TECHNICAL ALERT

May 16, 2002

PK543 Amplifiers and Lobby Speakers

THE RIGHT WAY

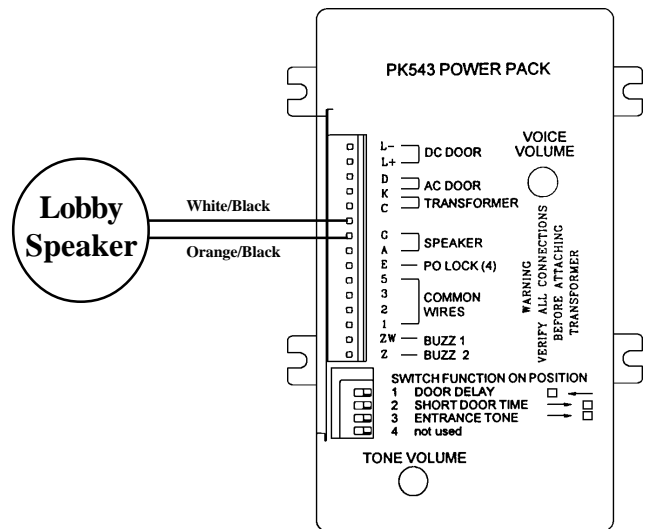
Here is what is happening.... on the newest PK543 amplifiers a new wire has been added to the wiring harness between the Orange and Orange/Black wires. This new wire is a White wire with a Black stripe. This White/Black wire is shown on the newest (IL487) wiring diagrams as terminal 'V', although the PK543 plastic cases were not yet printed with this new terminal 'V' between the 'C' and 'G' terminals. This White/Black 'V' wire is used only when the LI404B apartment strobe is connected to the PK543 amplifier, and is probably not used in 90+% of all installations. The correct way to connect the lobby speaker to the PK543 is to terminal 'G' and 'A' (Orange/Black and Black respectively). If the installer accidentally connects the lobby speaker to 'V' and 'G' (White/Black and Orange/Black respectively), even for a moment, the lobby speaker will blow, and there will be no voice on the system. Changing the speaker corrects this problem, and the PK543 is usually not harmed by the mis-wiring.

We have begun to place a warning label on the White/Black 'V' wires on PK543's we are now shipping in the hopes of avoiding this problem from now on. Please advise your installers of this situation right away. Thank you.
